ADDENDUM NO. 3 – May 18, 2026

**Missionary Minnie Lee Cotton Park Restroom
CIP PK 26-21**

This addendum amends the Contract Drawings and Specifications for this project as follows:

A400

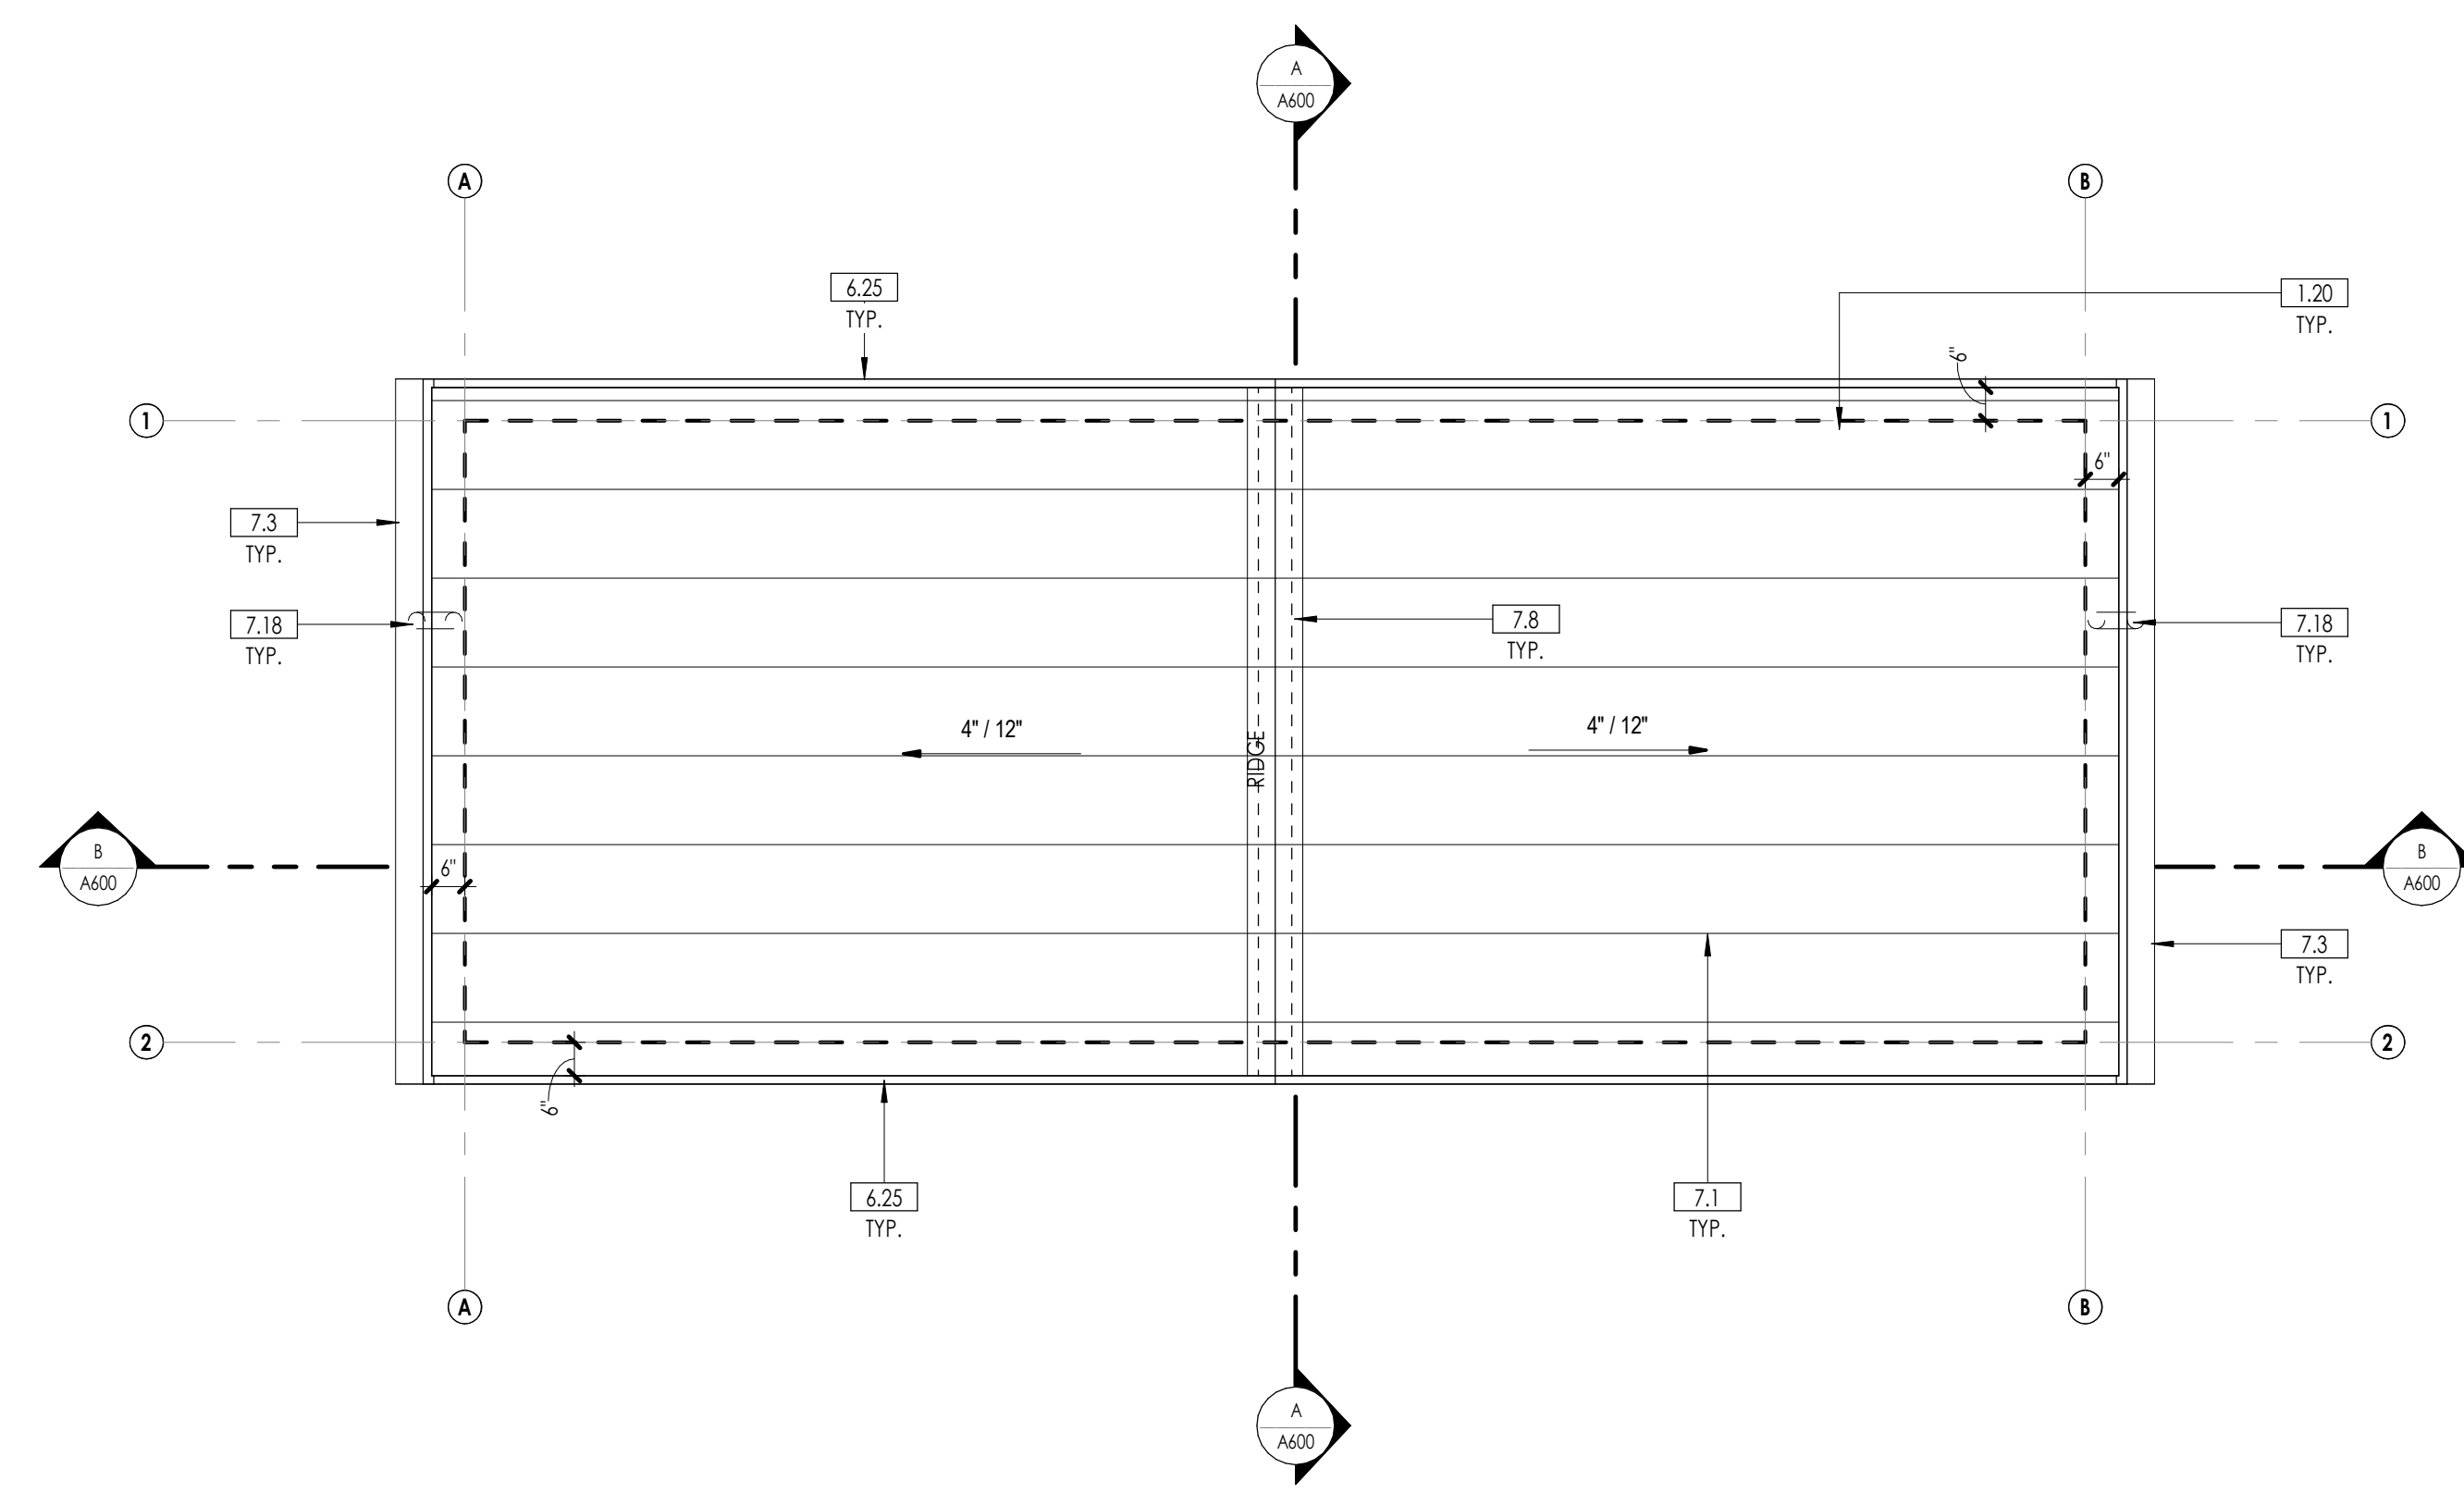
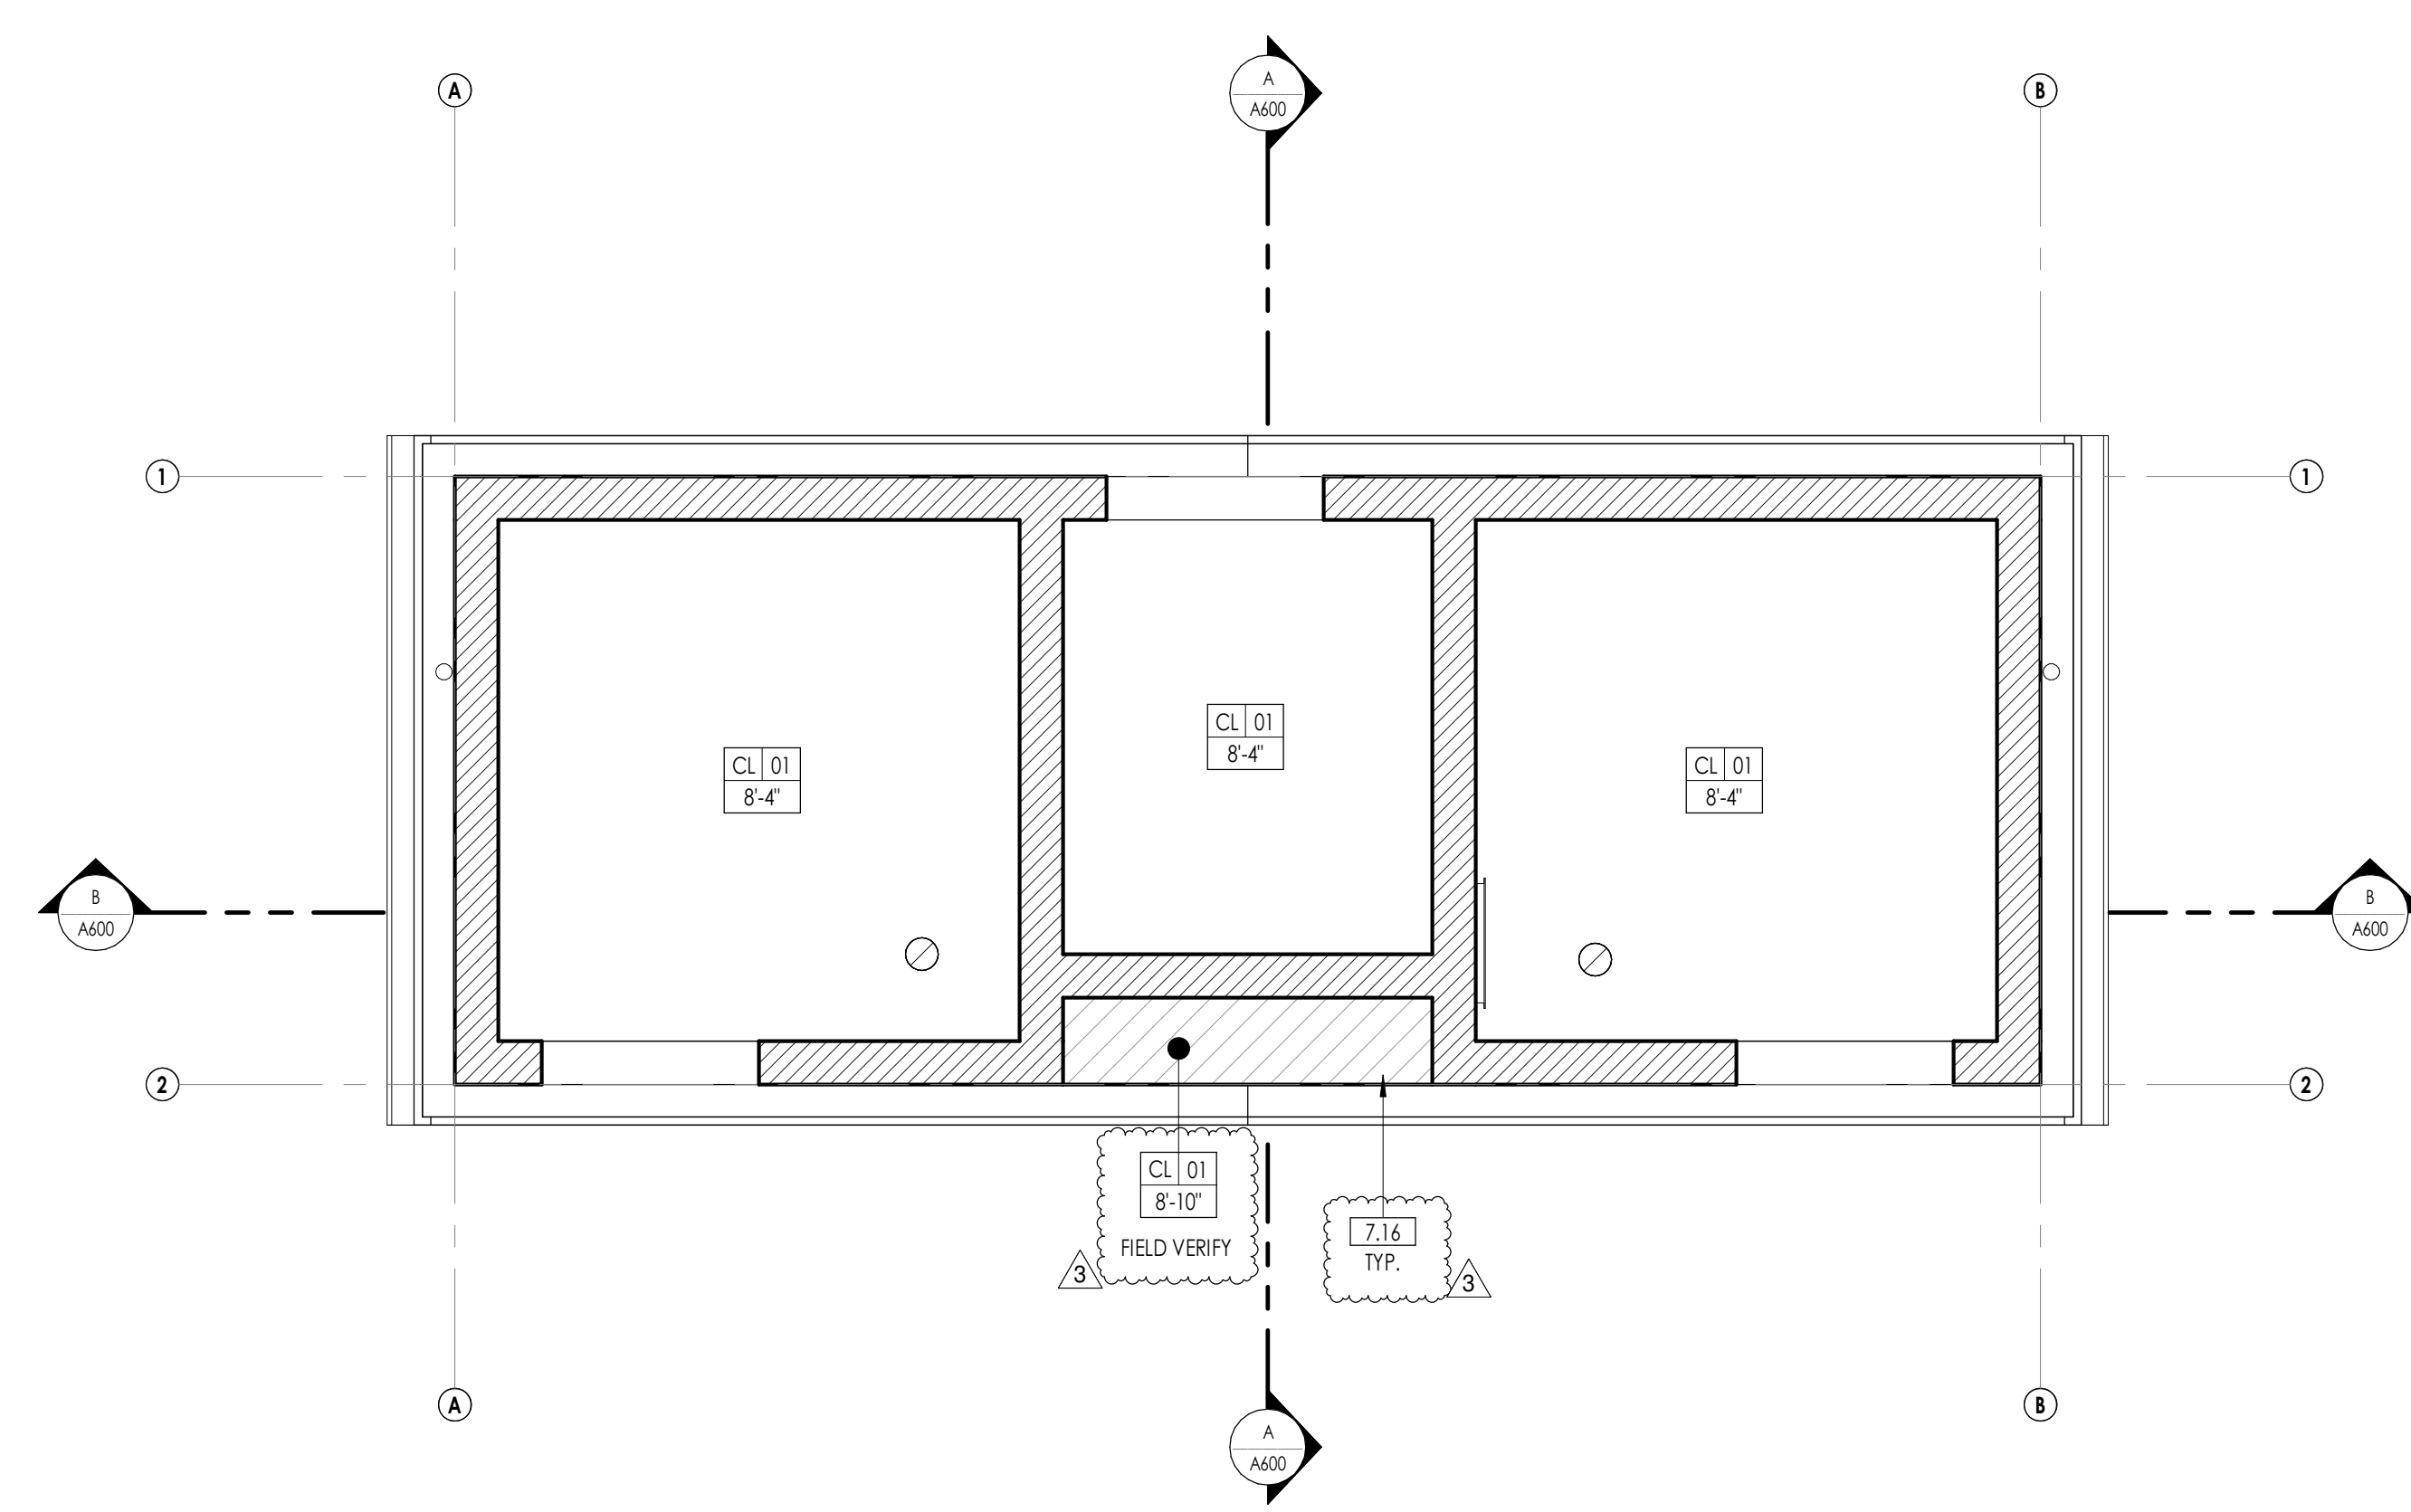
1. See Attachment “A”, – *MISSIONARY MINNIE LEE COTTON PARK RESTROOM, CIP PK 26-21 - REVISED BID SCHEDULE 2* adding temporary chain link jobsite fencing as Bid Item #25.
2. See attached, updated Plan Sheet A400.
